July 1, 2021

ADDENDUM No. 1

Oregon Central Fire Station

PARKING LOT JOINTING PLAN
SCALE: NO SCALE

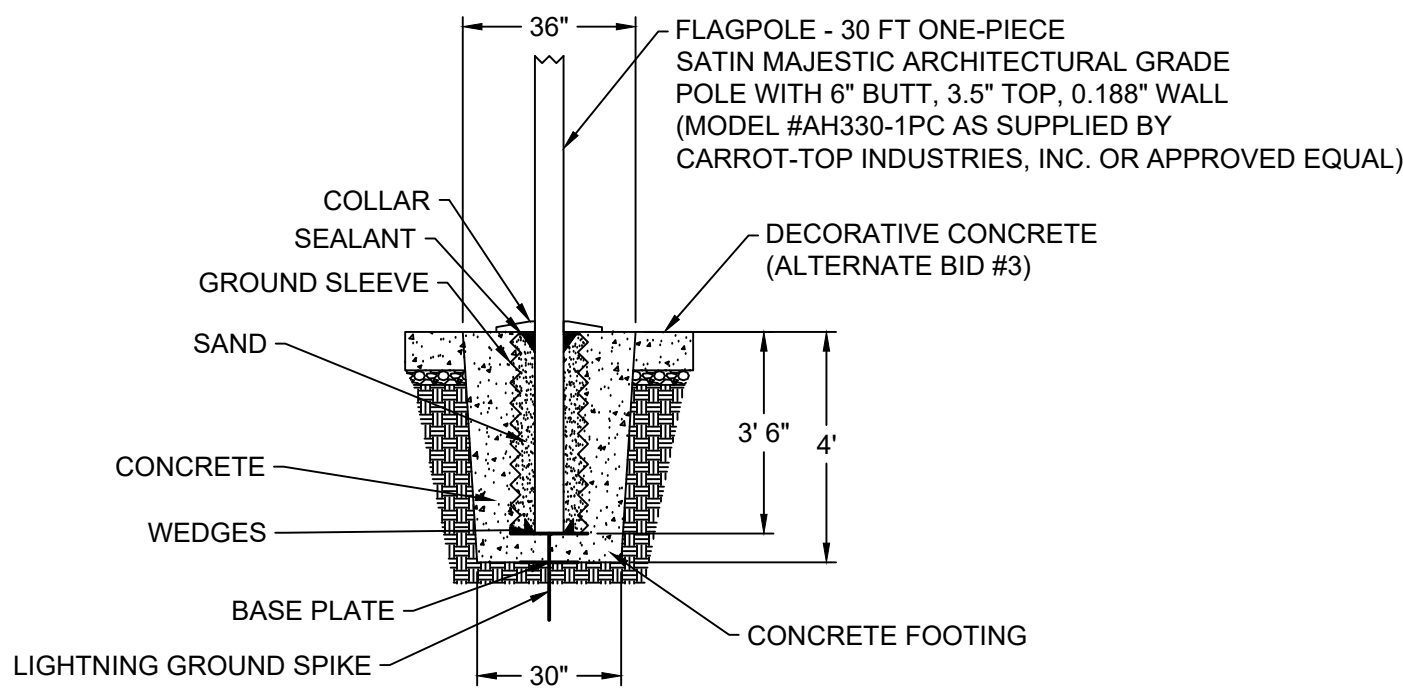
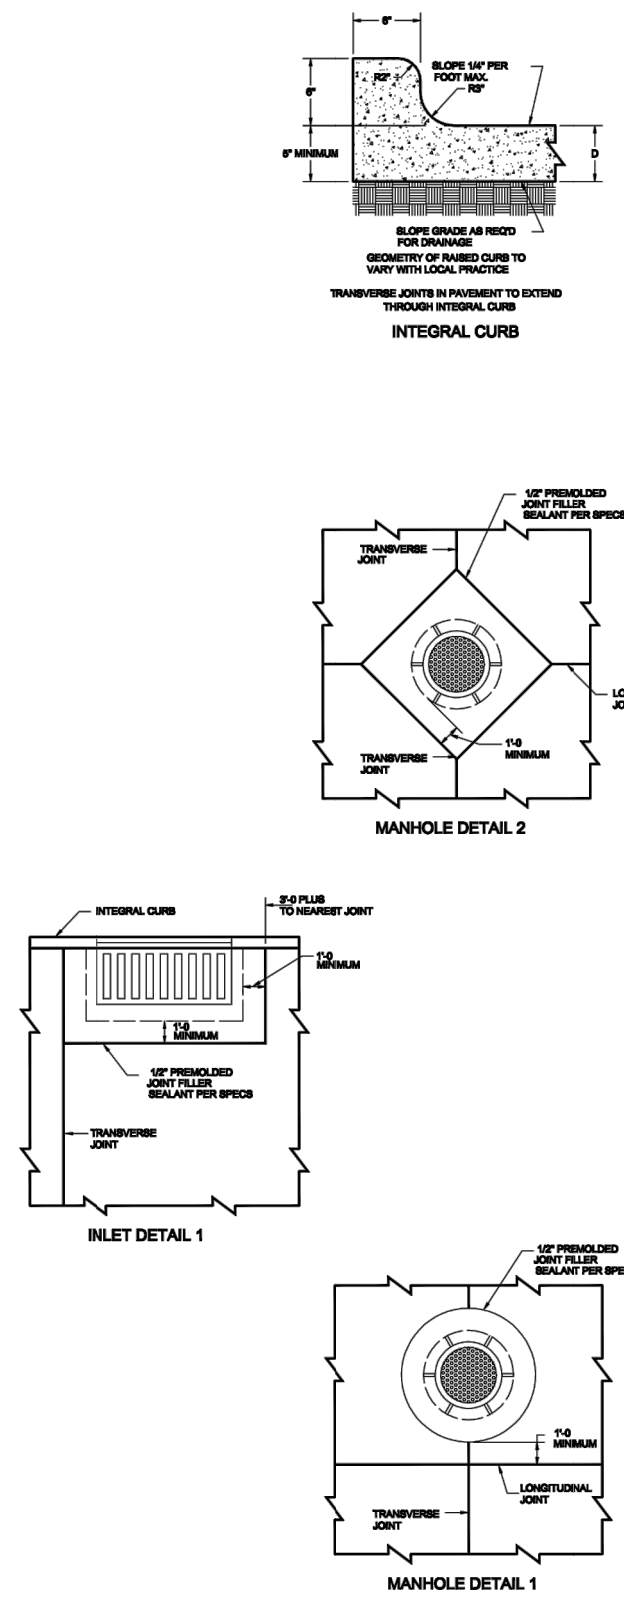
- See attached revised drawing C-104 for additional concrete pavement details and notes about alternate bid #2.

C-108

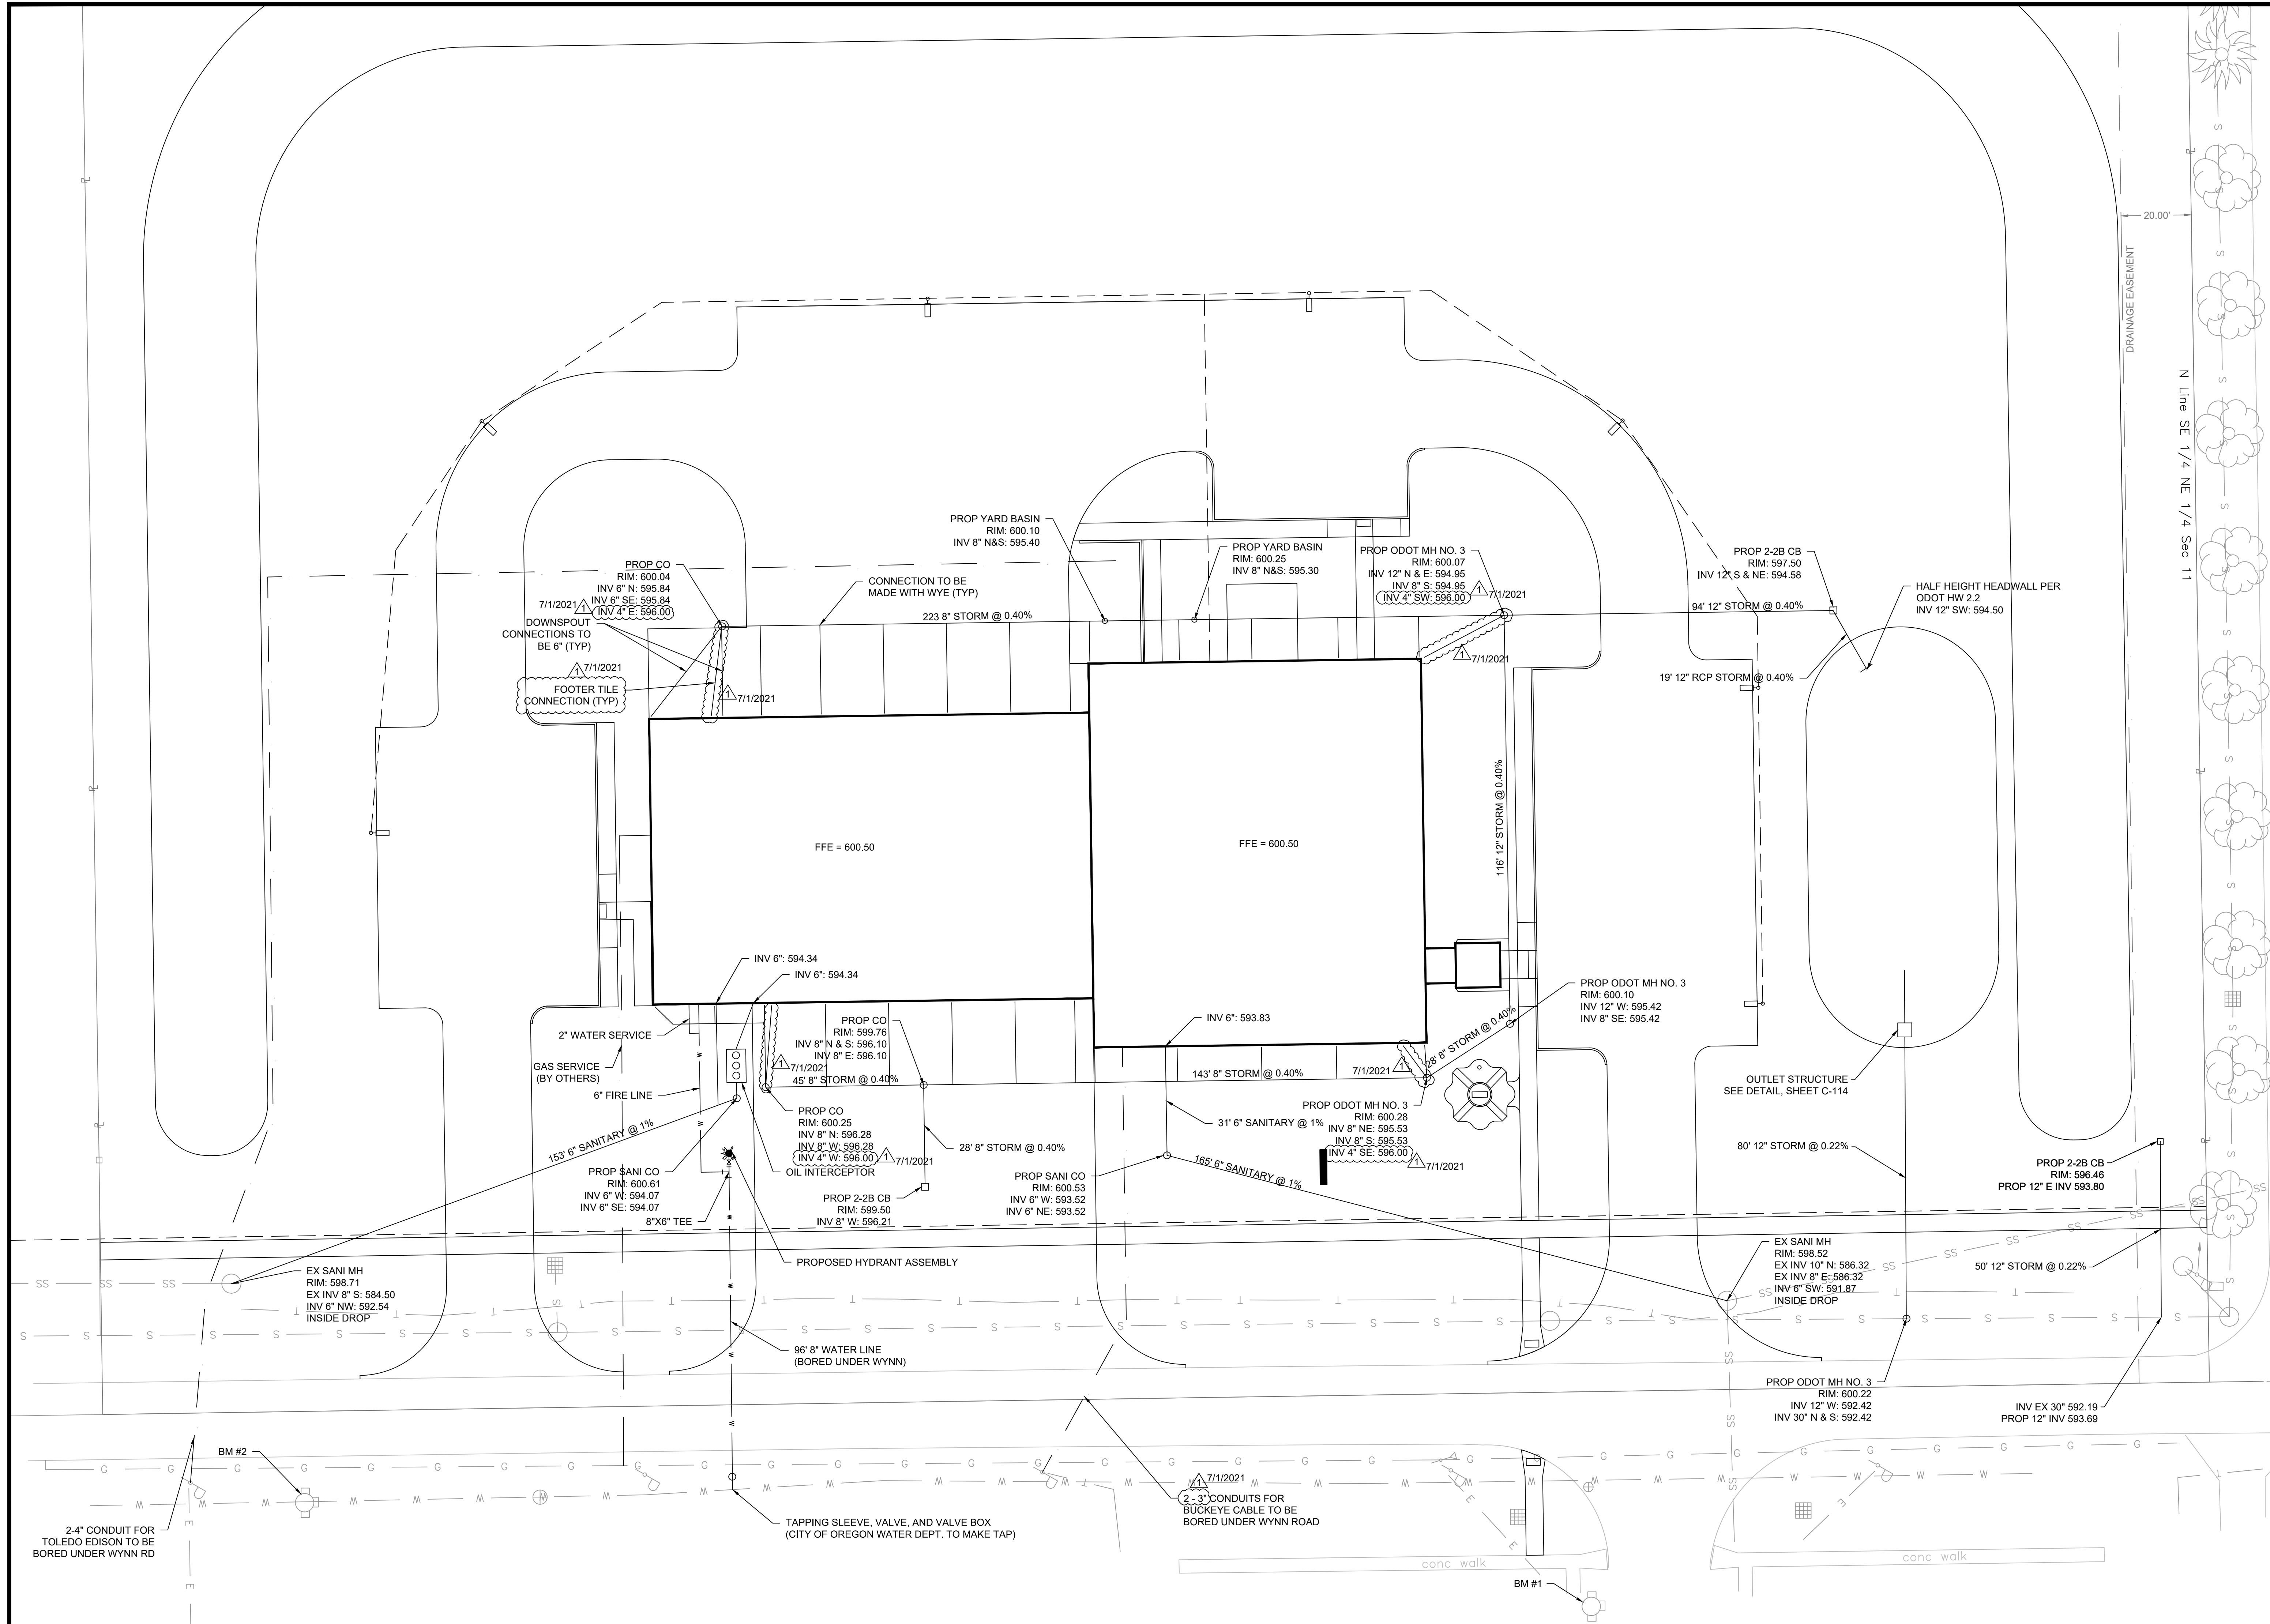
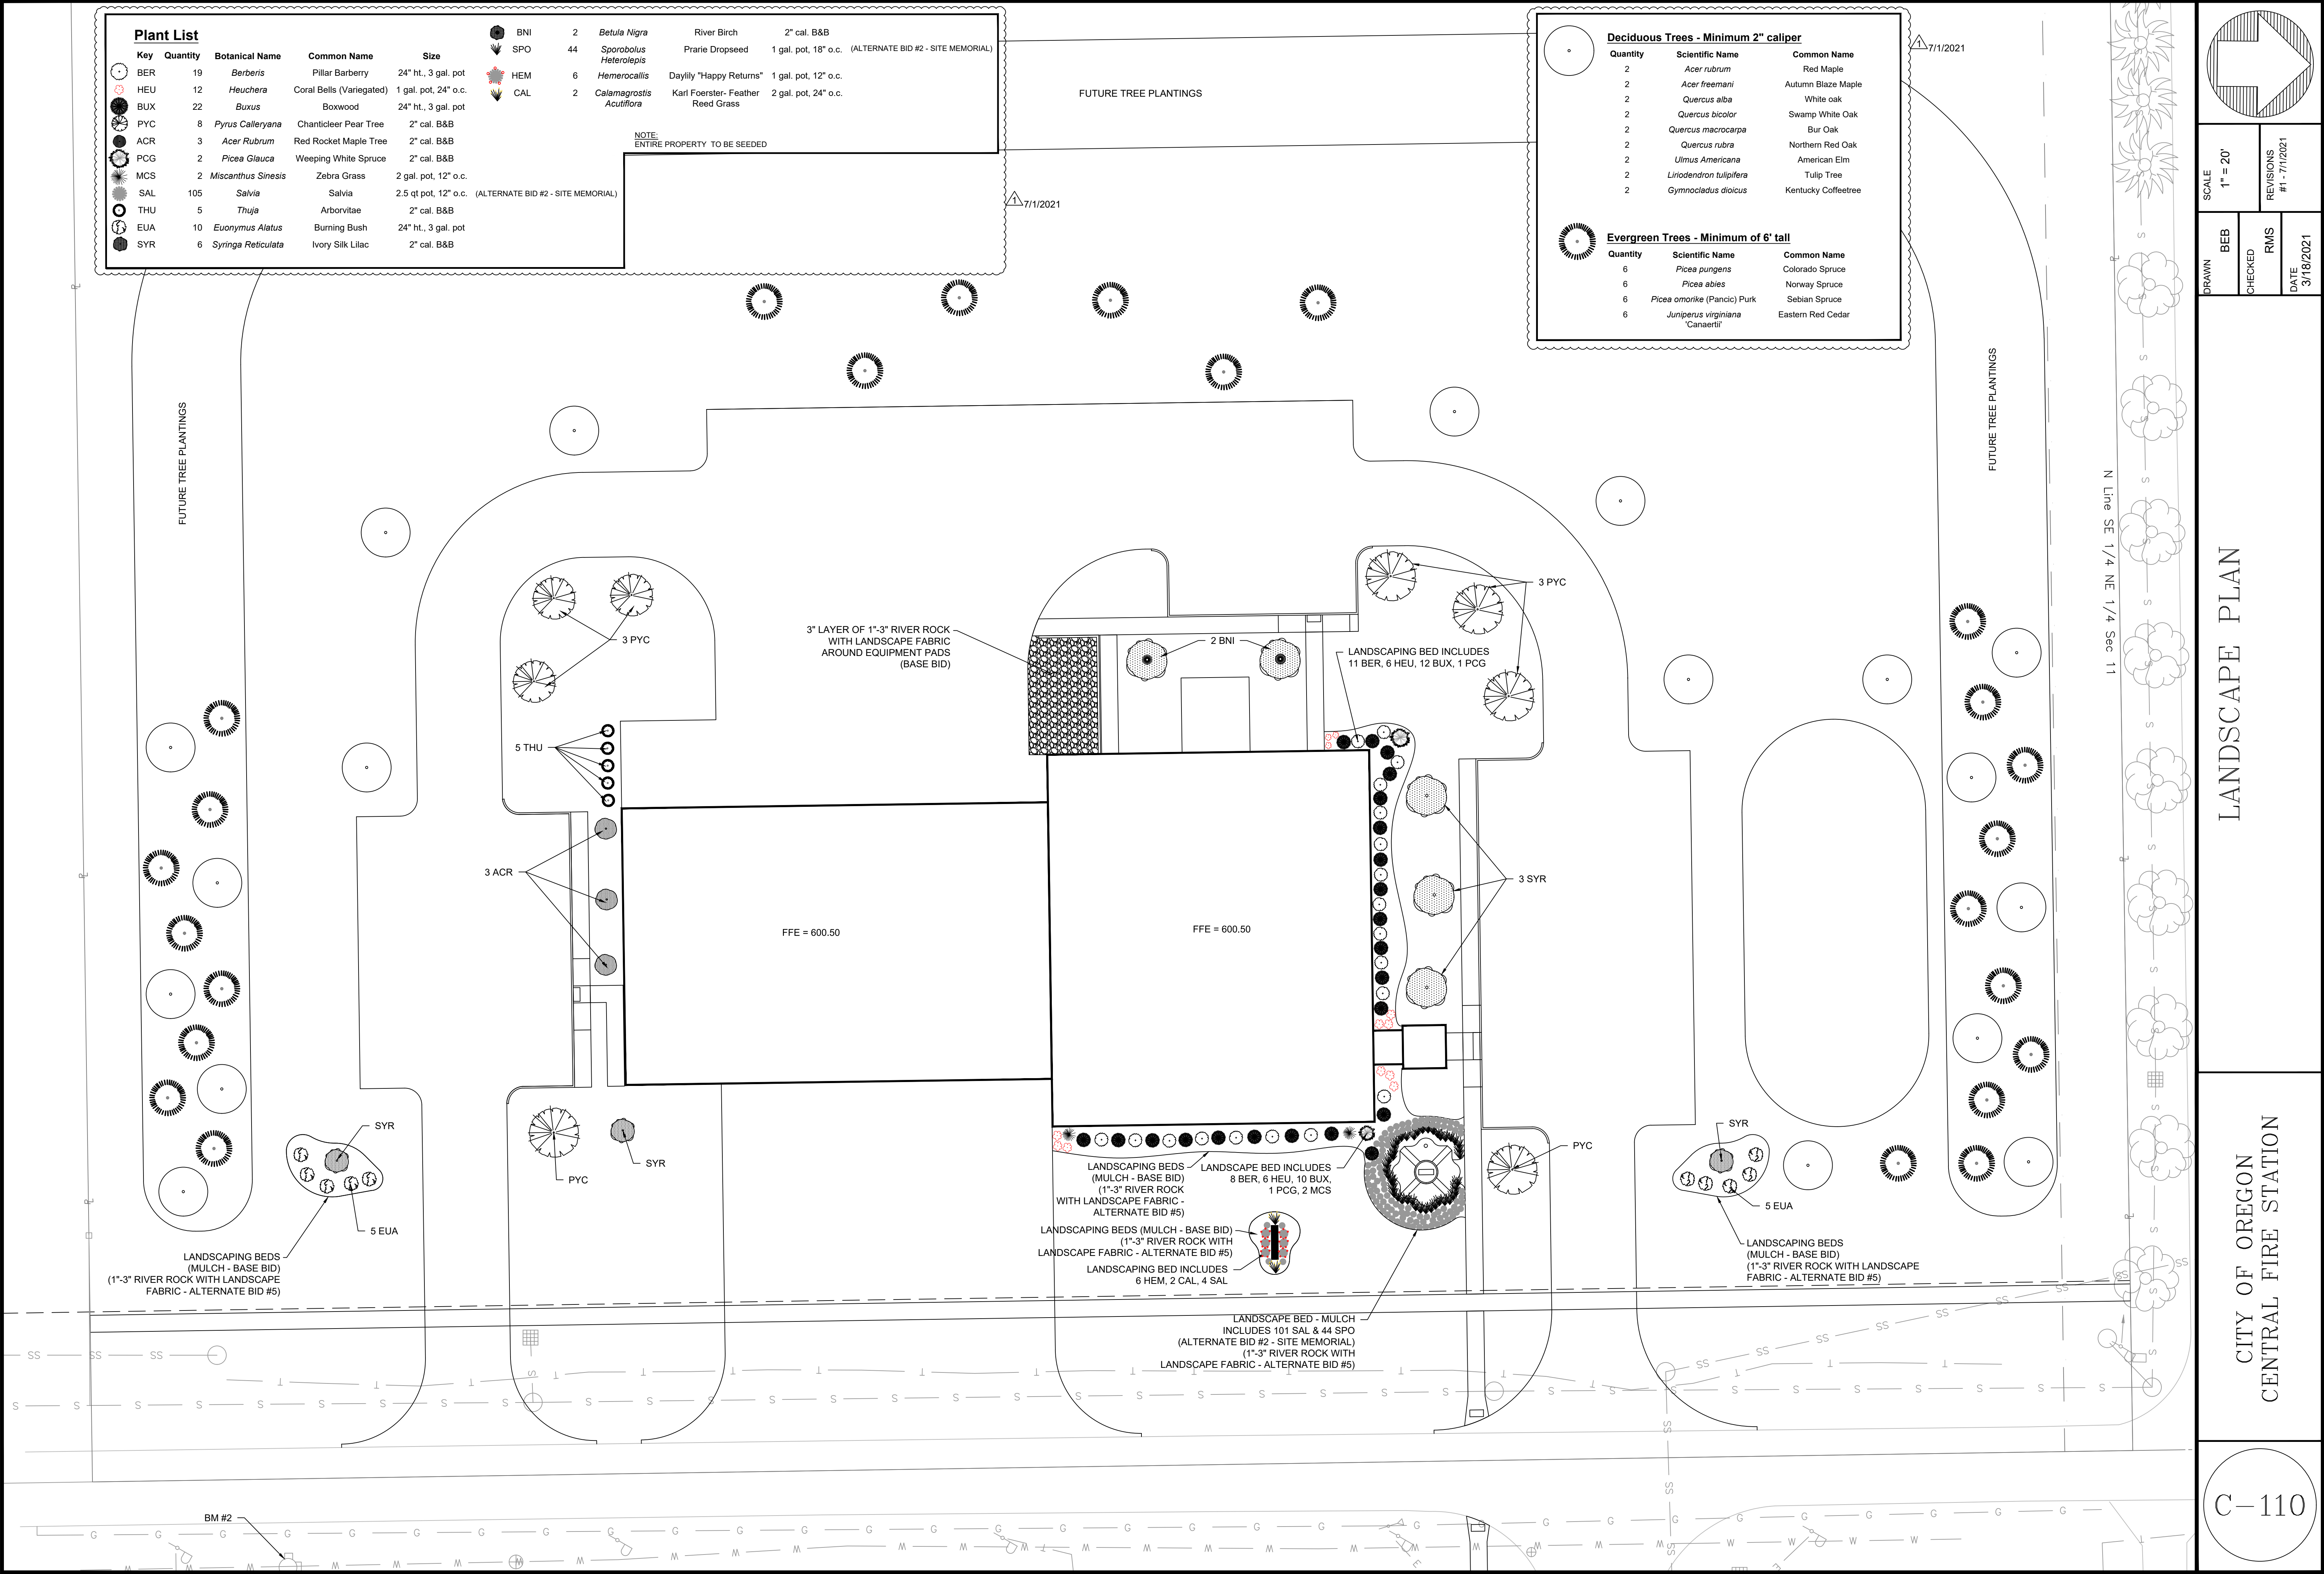
- See attached revised drawing C-108 for additional notation of footer tile connection and change to size of conduit for Buckeye Cable.
